Relevant Information for Local Planning Panel

FILE: D/2023/790 **DATE:** 28 February 2024

SUBJECT: Information Relevant To Item 5 – Development Application: 56A Allen Street, Glebe – D/2023/790

COMPLIANCE DIAGRAMS - FSR Calculations - Proposed

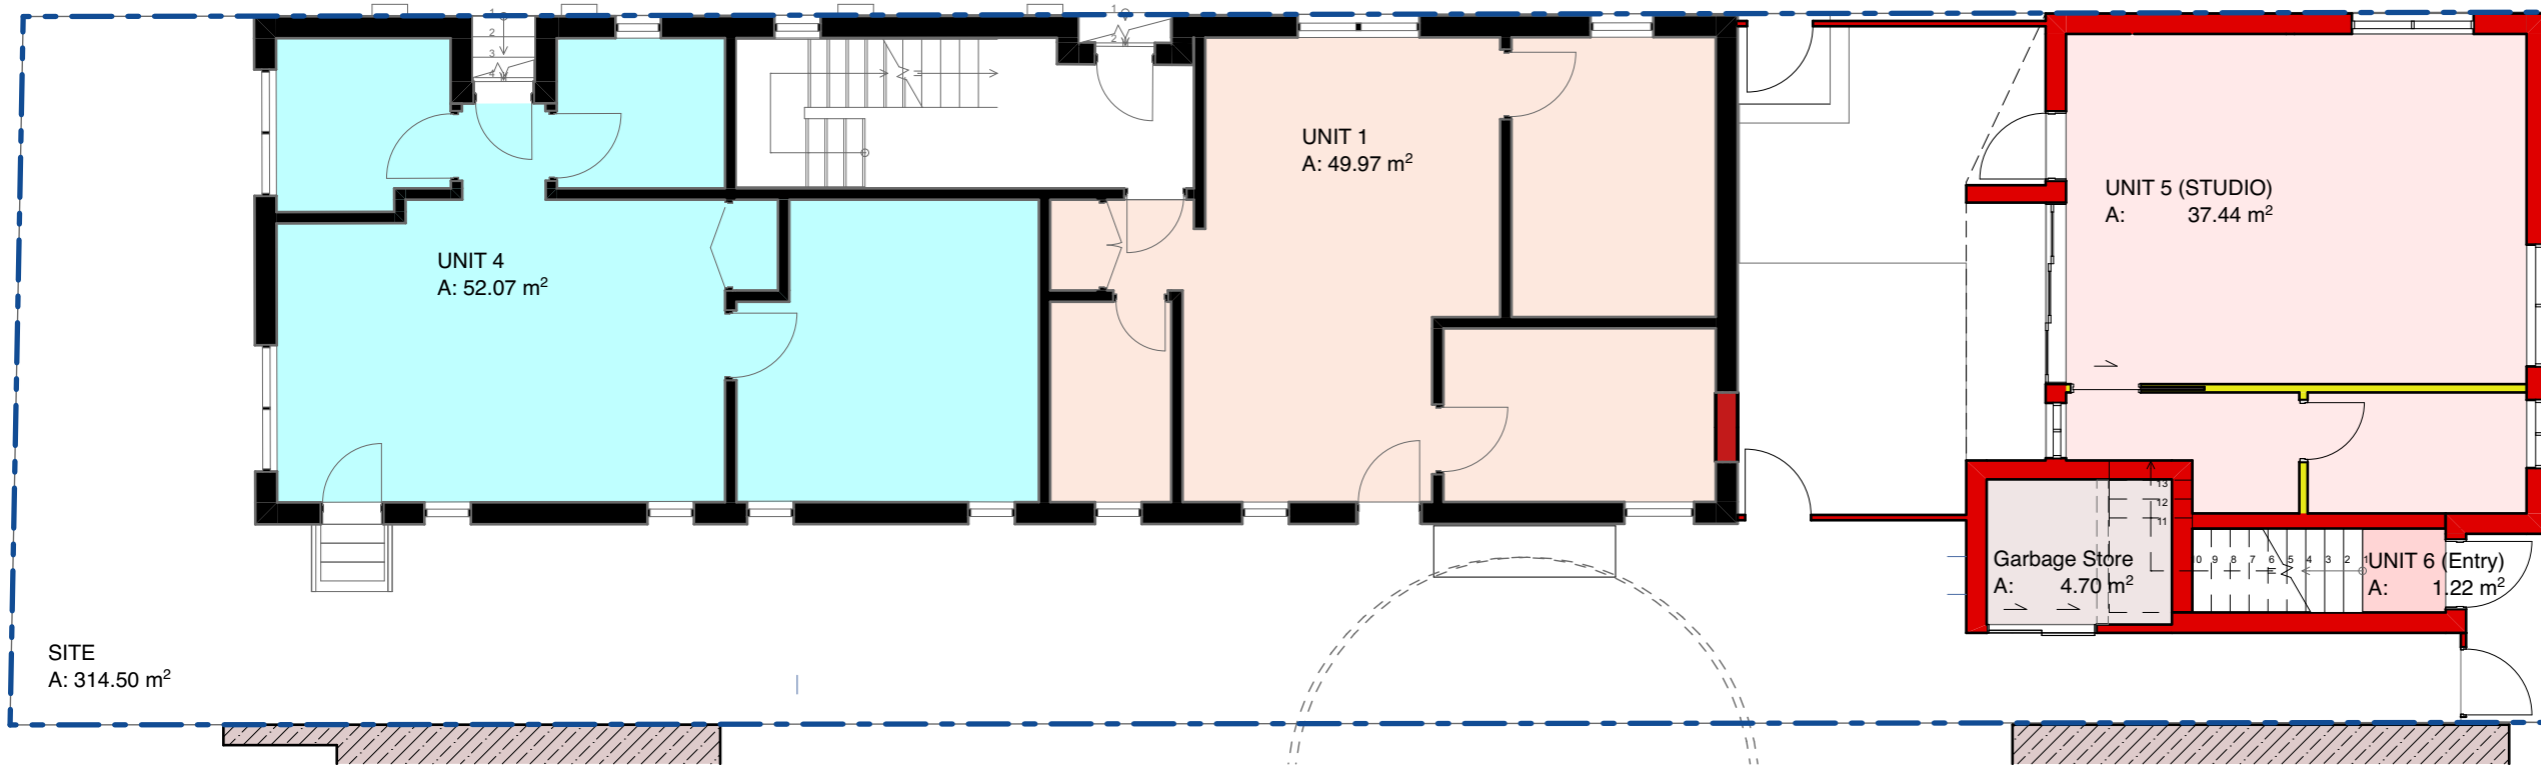
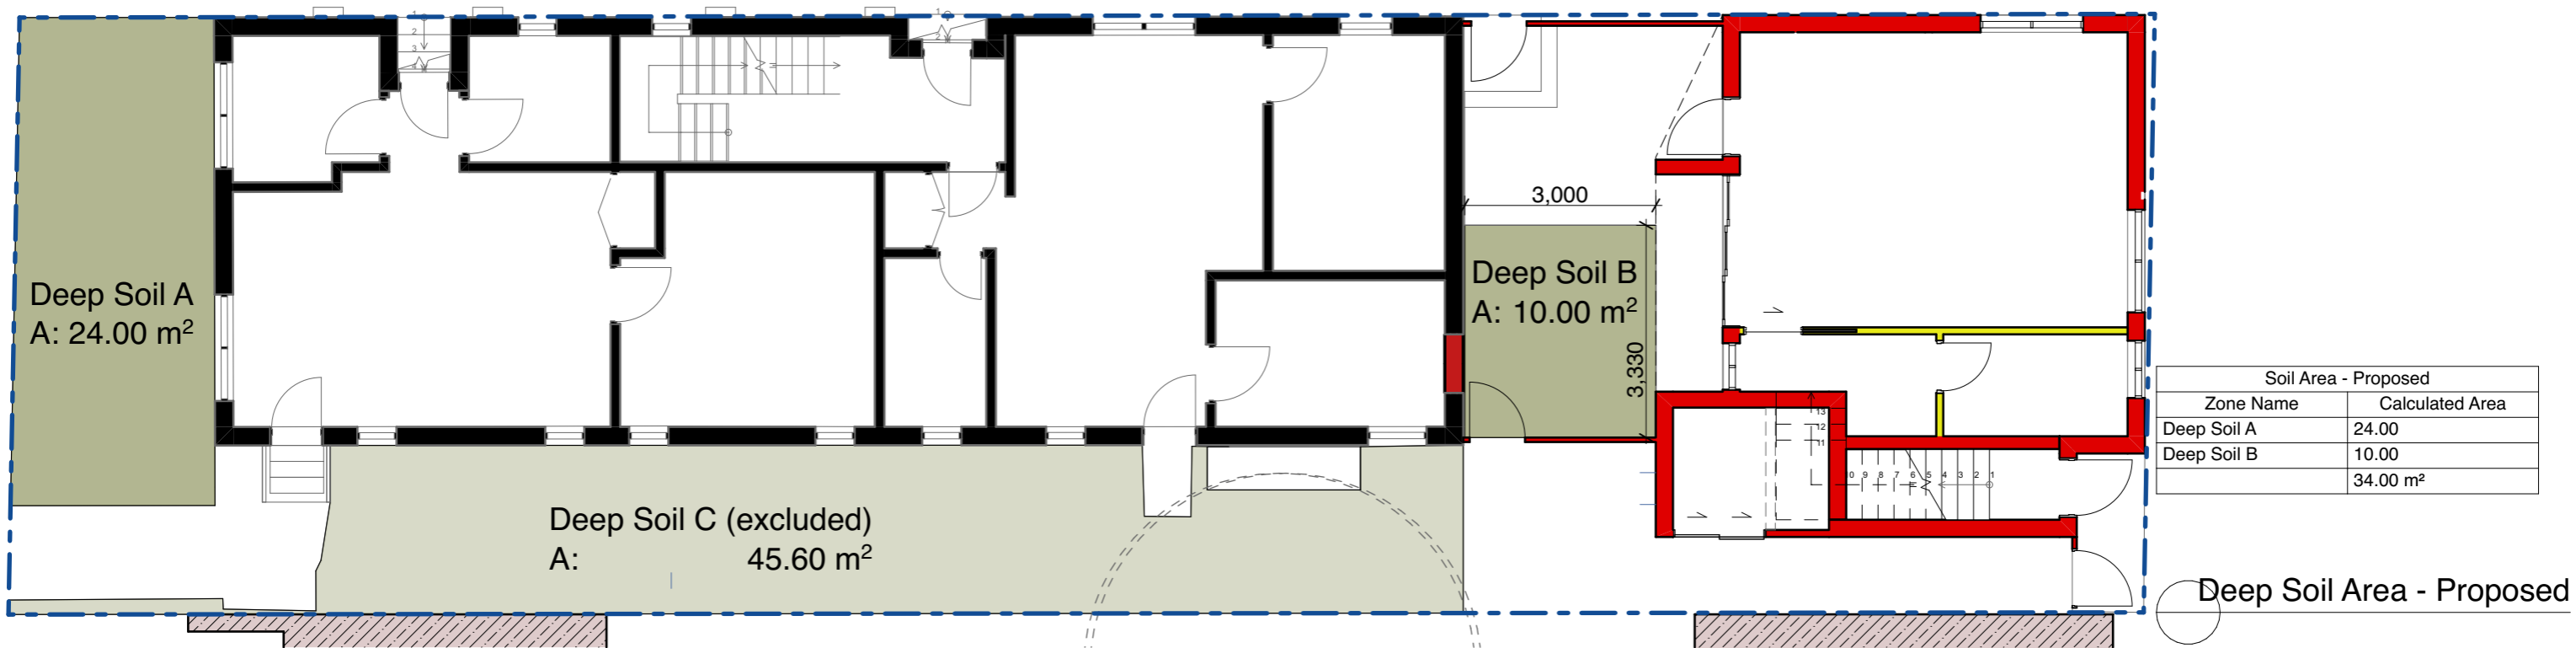
The applicant advises that the matters raised by Council can be resolved by proposing 1 or 2 units as affordable housing, that the revised proposal will comply with the 6m height standard, that flood planning will be addressed, and that they can comply with deep soil, canopy coverage, and bicycle parking requirements.

Issue	Summary	Intended Response/Resolution
1	FSR exceedance	<ul style="list-style-type: none"> • The proposal will include 1 unit to be made available to a registered CHP for rent (like St George Community Housing) for at least 15 years. This will be around 18% of GFA (1 of 6). Ordinarily, Clause 16 of SEPP (Housing) 2021, would allow an additional FSR of 30%, bring the FSR from 0.7:1 to 0.91:1, very close to the FSR proposed.

Drawing Title:
COMPLIANCE DIAGRAMS - Deep Soil Area Plan

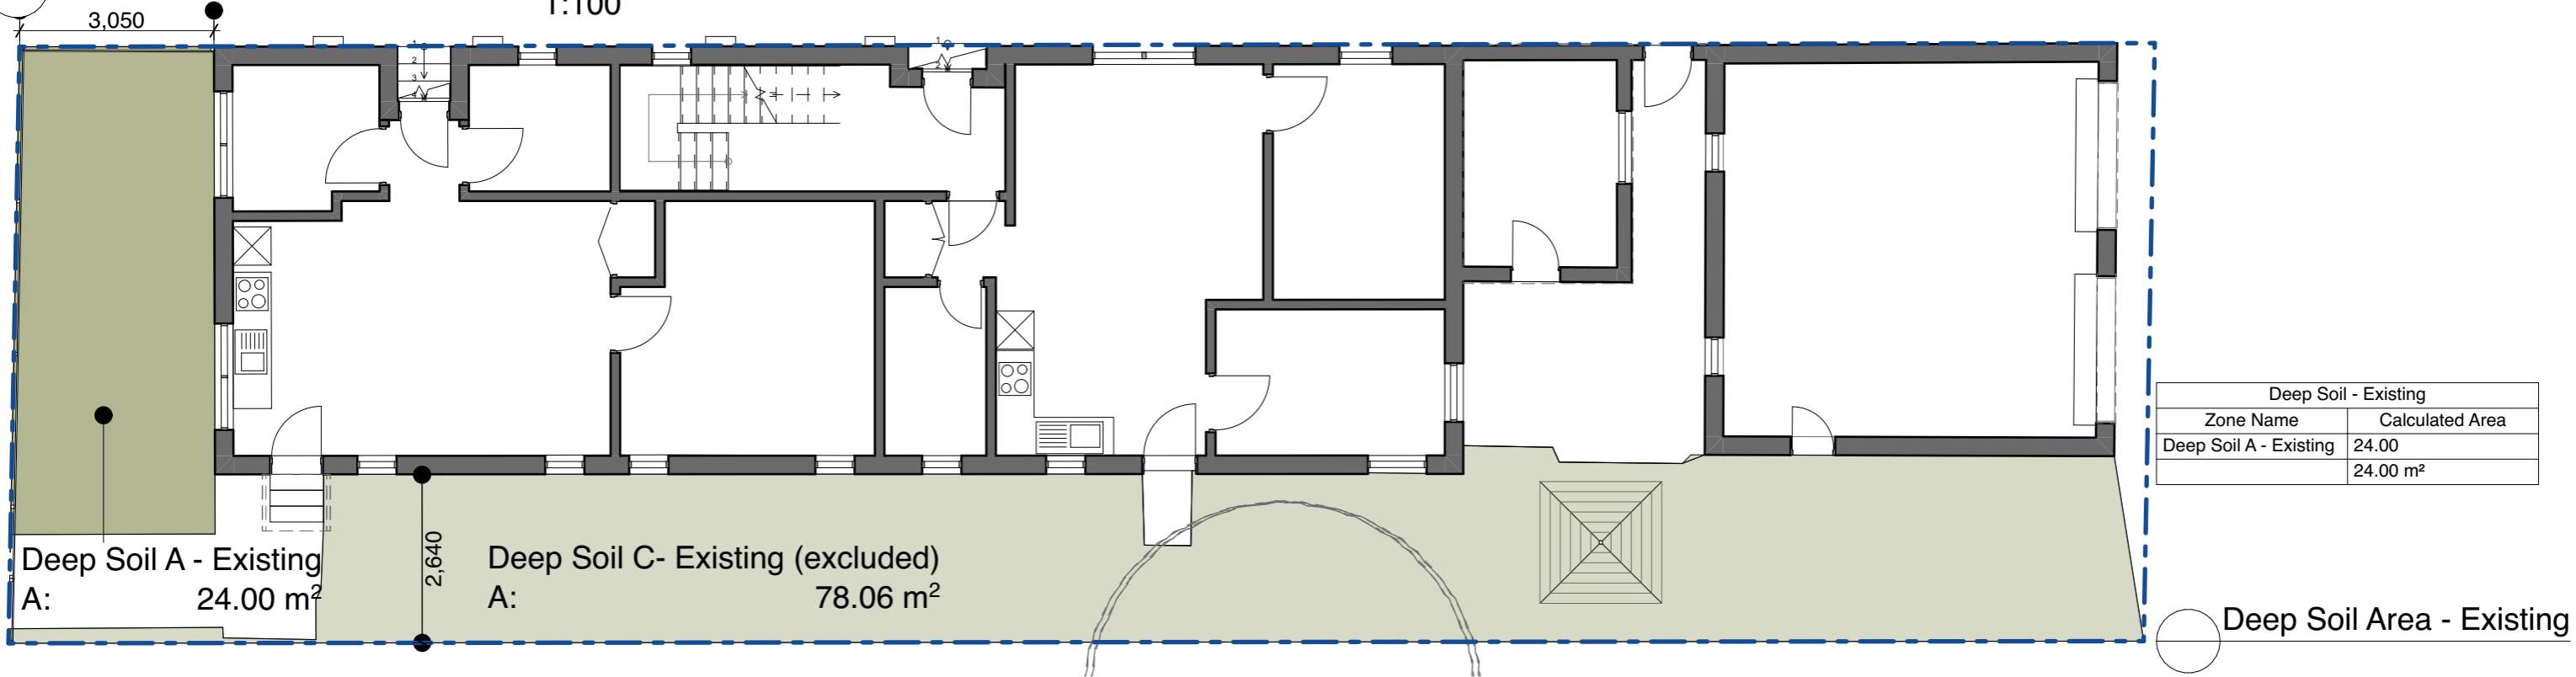
The applicant states that deep soil is expected to comply. The amended plans show an additional deep soil area of 10sqm. However, it appears that there may be structures above and below the new proposed area. This includes a structure (likely a pergola as previously proposed) above the area within the Unit 5 courtyard, though this is not clearly indicated on the plans. This is unsatisfactory as it does not demonstrate compliance or that compliance could be achieved with sufficient certainty

COMPLIANCE DIAGRAMS - Private Open Space - Proposed

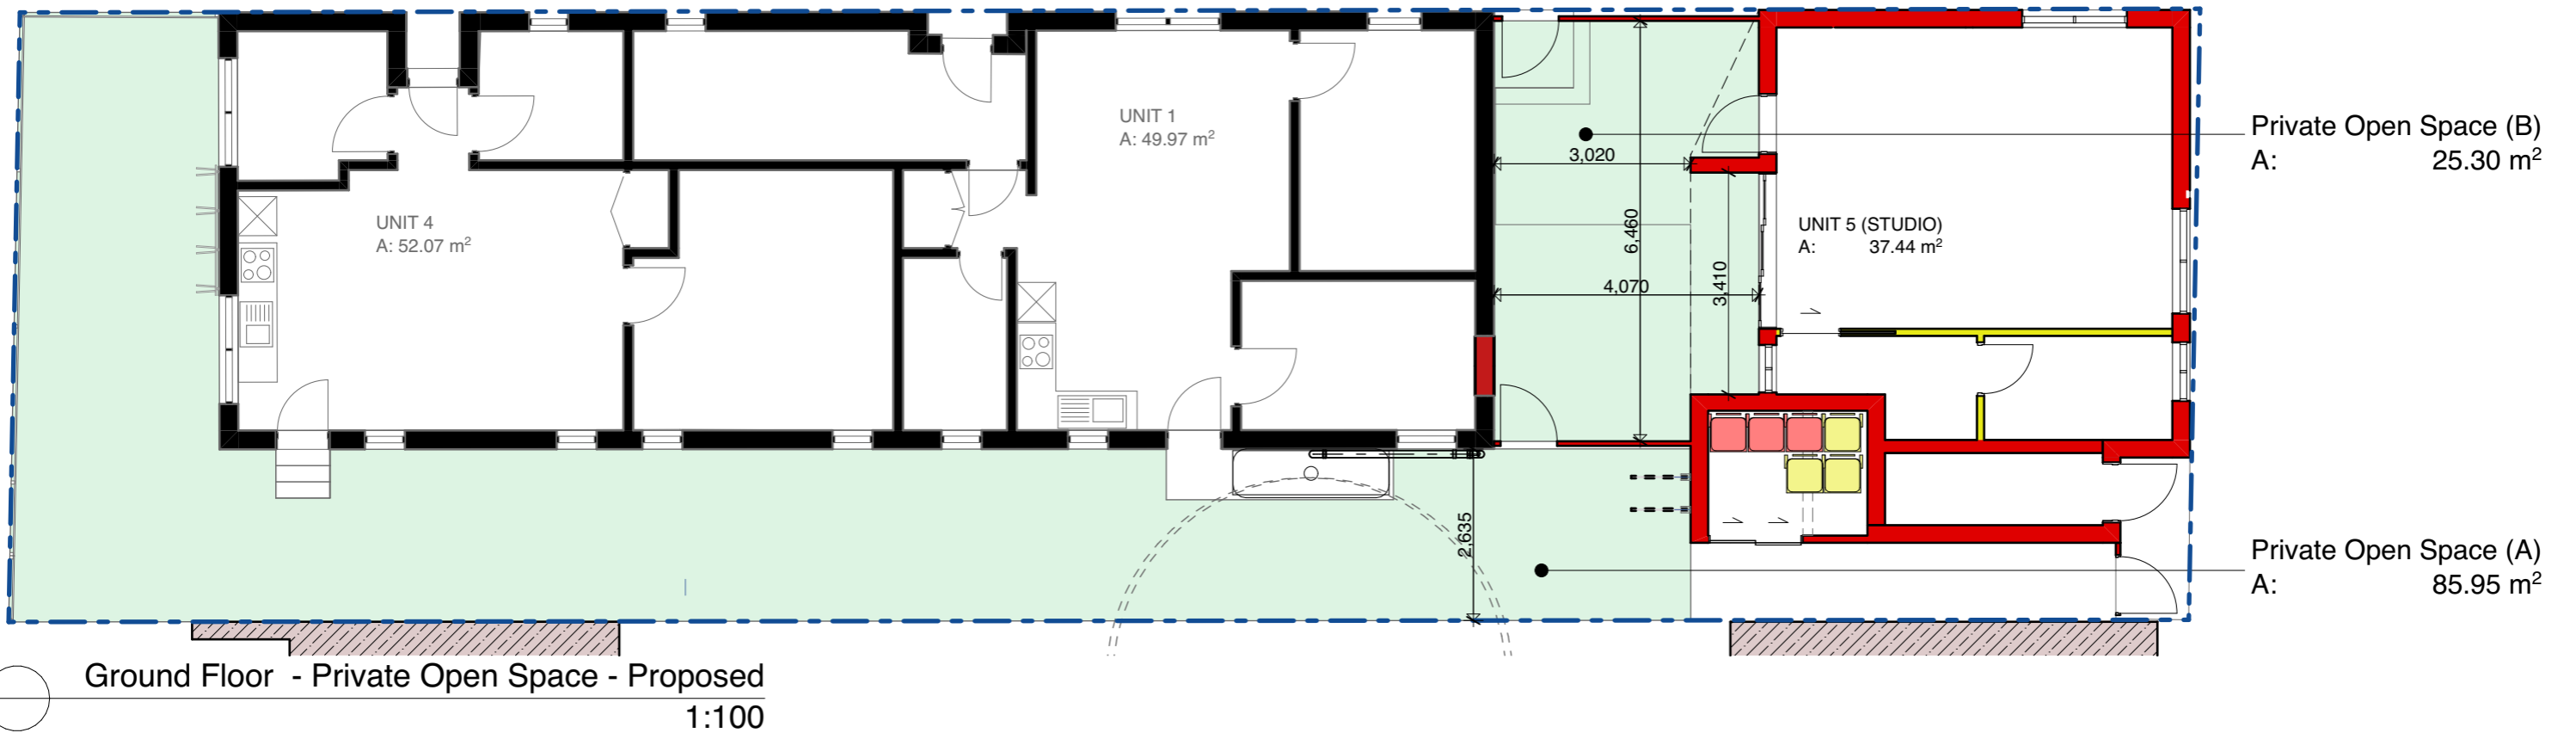
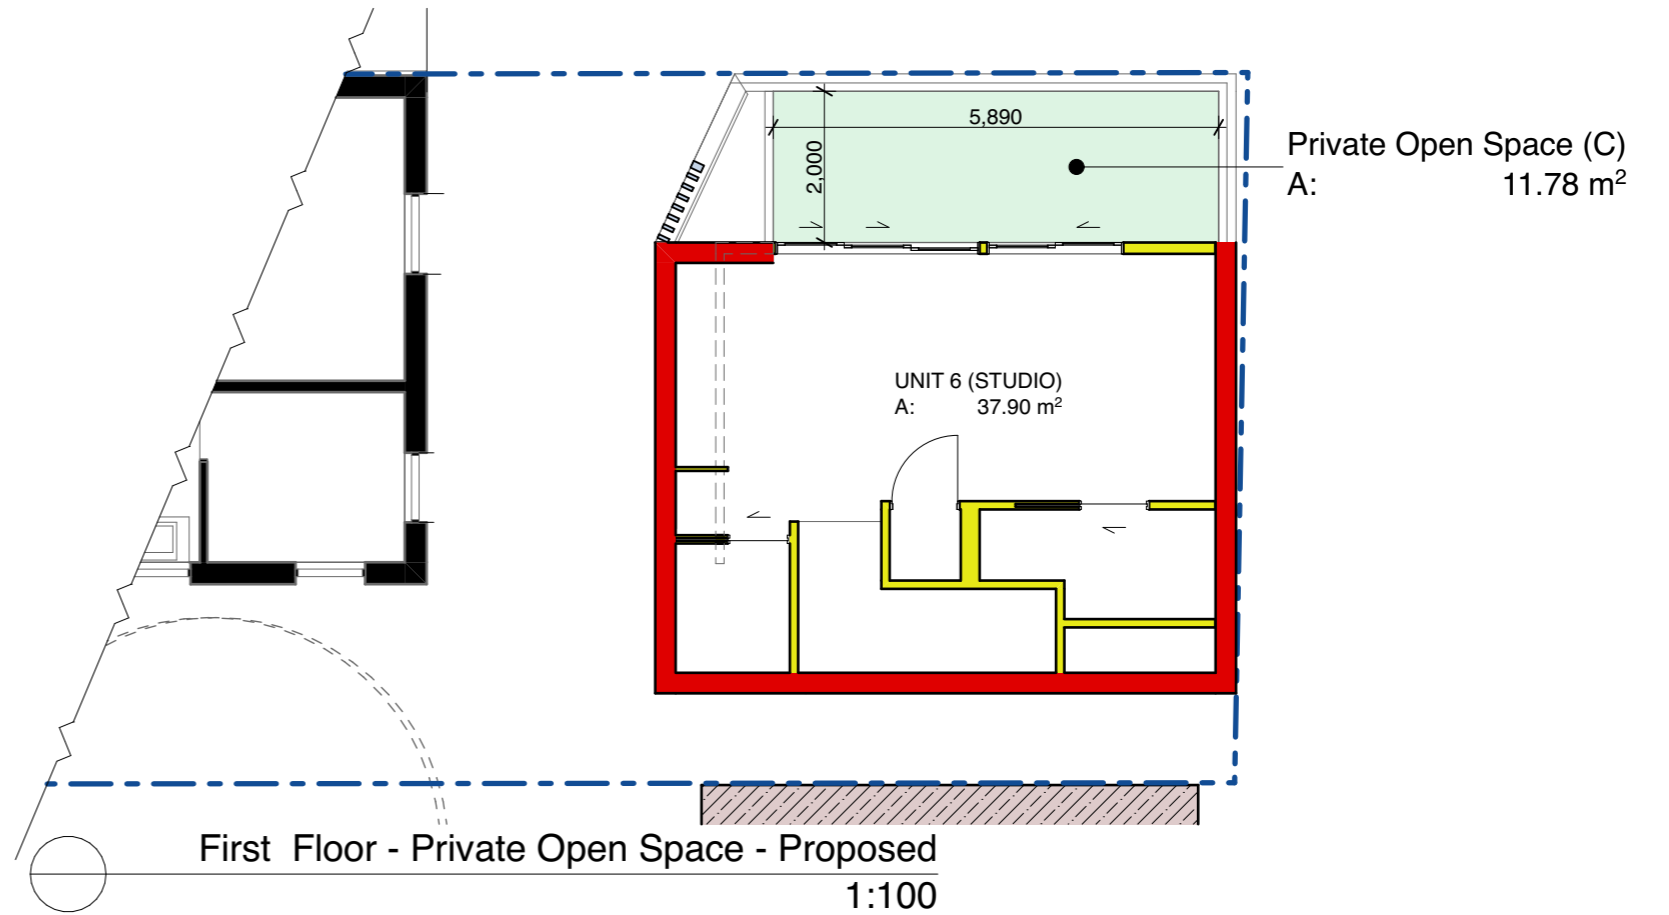
The applicant has increased the area of private open space for the ground floor unit to show a minimum dimension of 4 metres.

The applicant has not addressed how the development can provide the minimum required common open space. This is unsatisfactory as it does not demonstrate compliance or that compliance could be achieved with sufficient certainty.
